67/20 ENU 4639

Complaint - Yellow Warning Message "Brake Pads Worn" Appears in the Instrument Cluster: Observe Specified Procedure (67/20)

Vehicle Type: **Cayenne E-Hybrid (9YA/9YB)**

Subject: **Front wear indicator cables**

Shock absorber fork screws

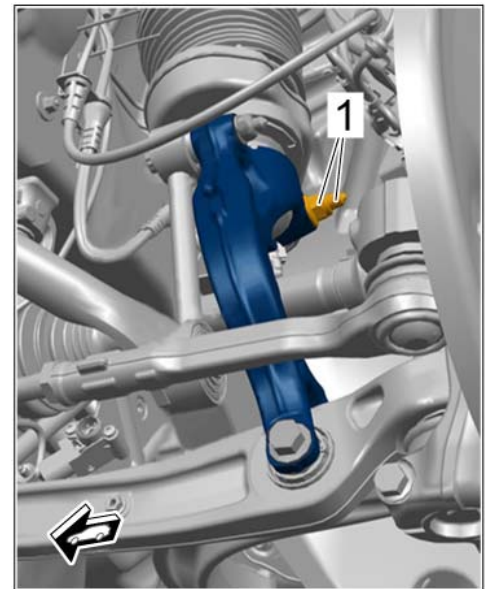
The wear indicator cables can catch on the screw on the shock absorber fork when the steering wheel is turned fully and the spring strut is extended.

- 1 Lift the wheel bearing housing up slightly using lifting equipment (e.g. **engine and gearbox jack**).
- 2 Remove screws securing shock absorber fork ⇒ *Shock absorber fork screws -1-* to the spring strut.
- 3 Insert **new** screws securing shock absorber fork ⇒ *Shock absorber fork screws -1-* to the spring strut **in the opposite direction to the installation direction shown in the illustration** and tighten them.

Initial tightening 40 Nm (30 ftlb.)

Final tightening +180°

Front brake calliper

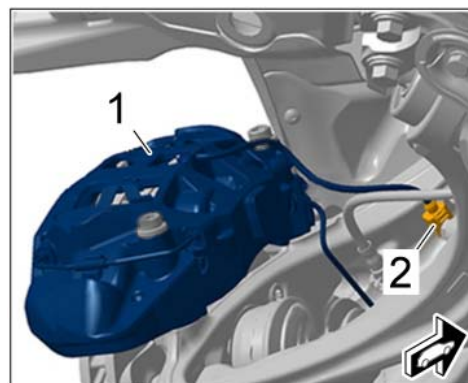
- 1 Unlock and disconnect electric plug connection ⇒ *Front brake calliper -2-*.
- 2 Unclip wear indicator cable from the brake calliper ⇒ *Front brake calliper -1-*.
- 3 Clip in **new** wear indicator cable.
- 4 Connect and lock electric plug connection ⇒ *Front brake calliper -2-*.
